**Customer Advice Note
CAN 184**

MPI PCB Rework

This Customer Advice note details information regarding a PCB rework for the MAXPRO Intrusion control panel hardware.

Identification

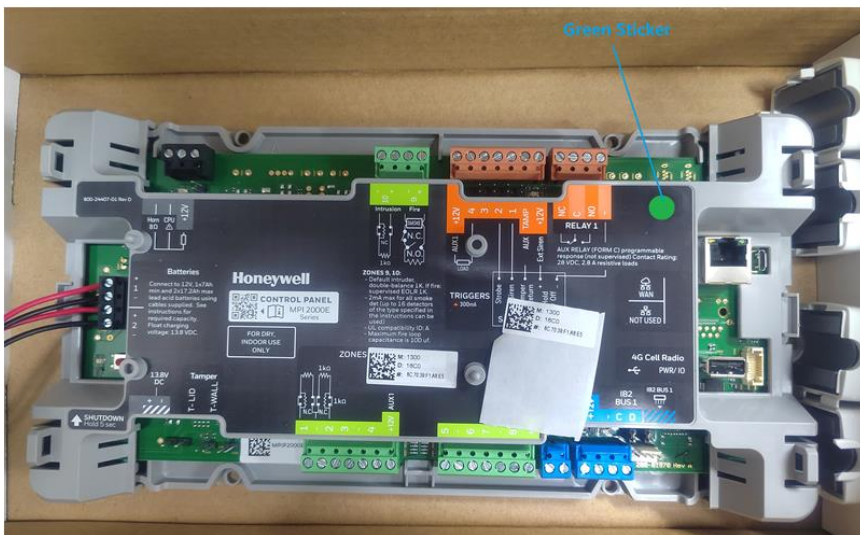
The Rework will be indicated by the **Green Sticker**.

Please be aware that MPI panels produced between October 17, 2022, and March 31, 2023, encountered registration issues with MPC due to incorrect certificates. We have now rectified this problem, and these panels are prepared for installation.

You can identify the reworked panels by the presence of a green sticker on the panel info card, indicating that the rework process is complete.
